# KDS Apparels Ltd. (9498)

20.April.2014

ACC RD  
on Fire and Building Safety in Bangladesh

## 2<sup>nd</sup> Priority 1 Concern

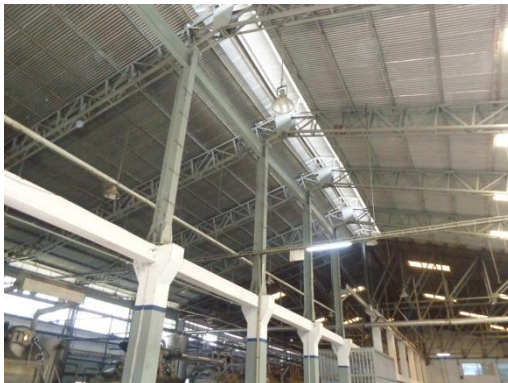
During our survey, we found two steel structure buildings at the ground floor and a steel shed structure at the roof. We also found two bridges connecting both main buildings. Unorthodox details were noted in all parts.

As mentioned, no structural drawings were available for any of the steelwork structures.

Notable points:

1. Wind column in weak axis
2. Unrestrained bottom chords for uplift forces
3. Long spans for angles used for decking support
4. Improvised splices or bearing points

We require a full Detailed Engineering Assessment of the steelwork on this facility.

- Carry out a full Detailed Engineering Assessment of the steel structures evaluating capacities under gravity, lateral and uplift forces.
